April 14 2021 MTE File No.: 47825-100

### Re: Review of the Natural Heritage Study for Kilally Road South EA

# **Kilally South EA Study Area**

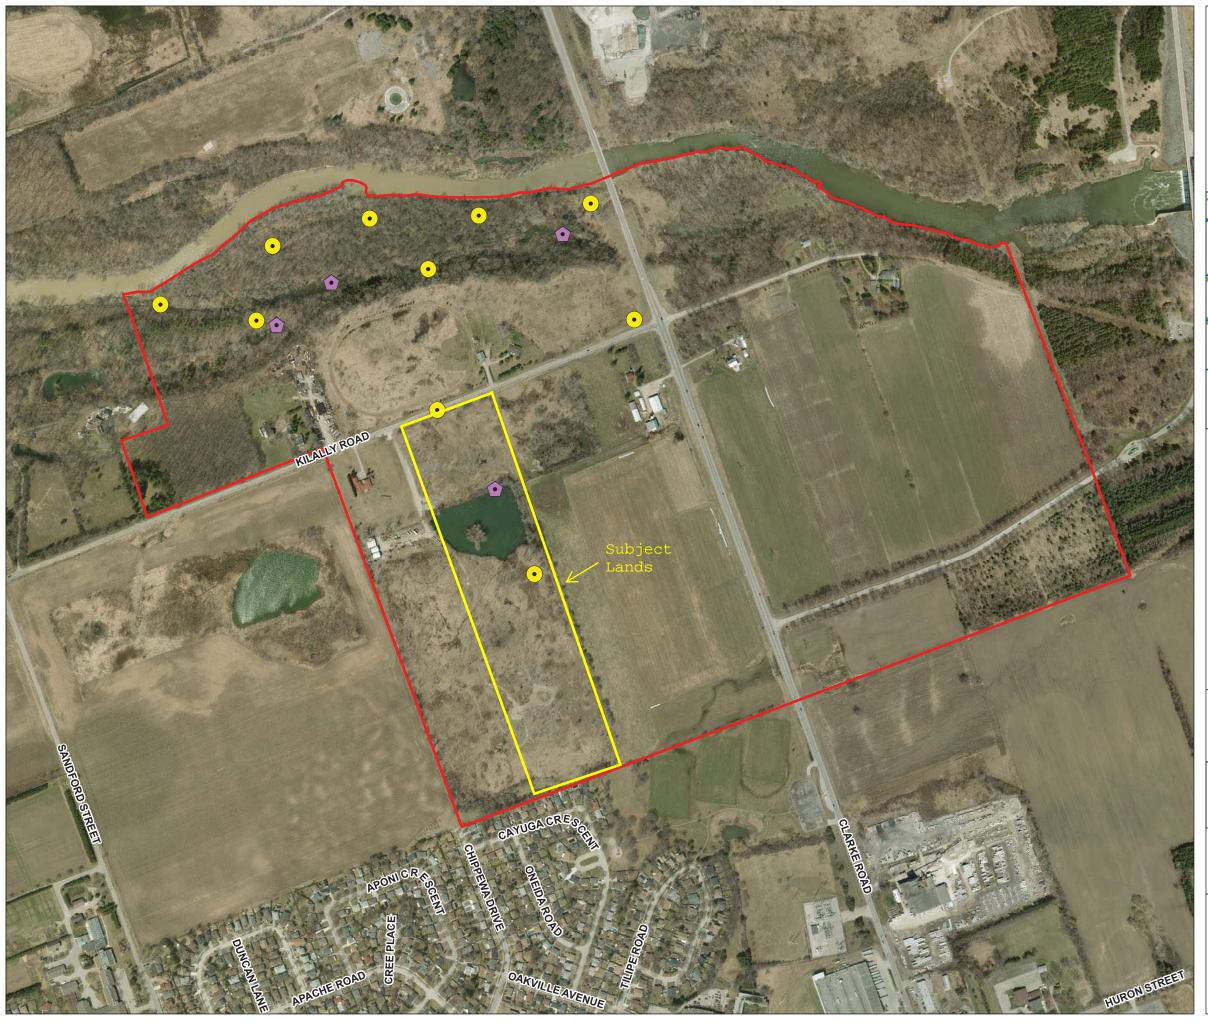
On Map 1 of the report, North-South has identified two study locations on the property [Map attached with Auburn property ownership highlighted), which are within the Auburn land holdings. A review of the field notes suggest the amphibian surveys were done at the roadside, not next to the aggregate extraction pond. That map is incorrect and should be fixed. Further, there is a breeding bird survey location noted but none of the breeding bird studies were compartmentalized to the specific locations. Again, without access permission, this call study location is incorrect and should be deleted from Map 1 of the EIS.
